Product Change Notice

PCN#: EE-PCN17048

End of life notification and recommended replacements for A5000, CB5000 and CB1000 terminal blocks

CB1000

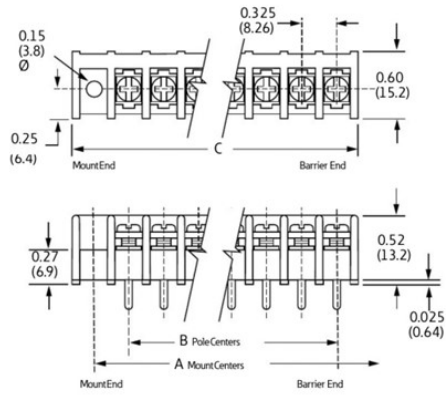
CB1000 to CB11
